SUBJECT: UTILITY COMMENTS ON THE H. B. ROBINSON PTS STUDY FOR
SUBMISSION TO THE PUBLIC DOCUMENT ROOM

A2-TS-115
CNS-84-265

The purpose of this letter is to document our review of the August, 1984 report, "Thermal-Hydraulic Analyses of Overcooling Sequences for the H. B. Robinson Unit 2 Pressurized Thermal Shock Study," NUREG/CR-3935, EGG-2335, Draft Report.

Comments on Small Model:

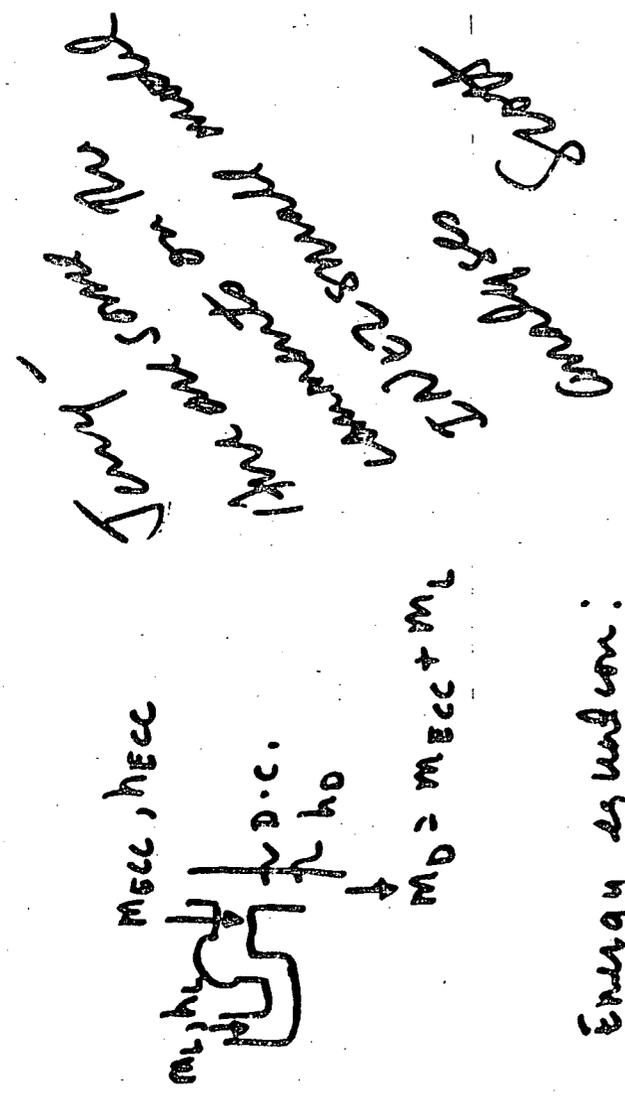
The results from the small model appear quite good. There are two problems that could be alleviated however.

1. Engineering judgement to a large degree has to be relied upon for asymmetric transients. This could have been avoided with a larger model, say 30 - 40 nodes.
2. Nat'l circulation buoyancy effects might be questioned since the elevation heads are not correctly taken into account. Judging the results however seems to indicate that the noding is adequate for extrapolation purposes and certainly beats "eyeballing" as used previously.

It is not quite clear whether the break flow was taken into account in the use of the downcomer temperature extrapolation. It may have been taken into account in the term m_L , but this is not clear. The relationship for the downcomer temperature might read as:

$$\bar{T}_D = \frac{(m_L - m_B)T + m_{ecc}T_{ecc}}{m_{ecc} + m_L} - \alpha \frac{dT}{dt}$$
